# Economic and Social Council

#### 183rd session

## Proposal for the 04 series of amendments to UN Regulation No. 118 (Burning behaviour of materials)

### Submitted by the Working Party on General Safety Provisions \*, \*\*

**Example 2**

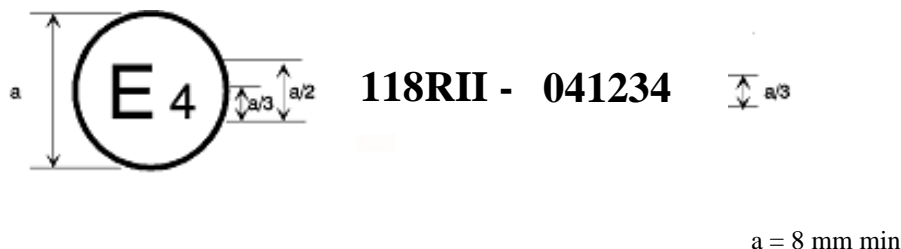
Annex 5, amend to read:

The above approval mark affixed to a component shows that the type concerned was approved in the Netherlands (E 4) pursuant to Part II of UN Regulation No. 118 under approval number 041234. The first two digits (04) of the approval number indicate that the approval was granted in accordance with the requirements of the 04 series of amendments to UN Regulation No. 118.

The additional symbol  indicates the direction which the component may be installed.

The symbol  indicates that the component fulfils the requirements in paragraph 6.2.2.

The symbol  indicates an approval as a complete device such as seats, separation walls, etc.
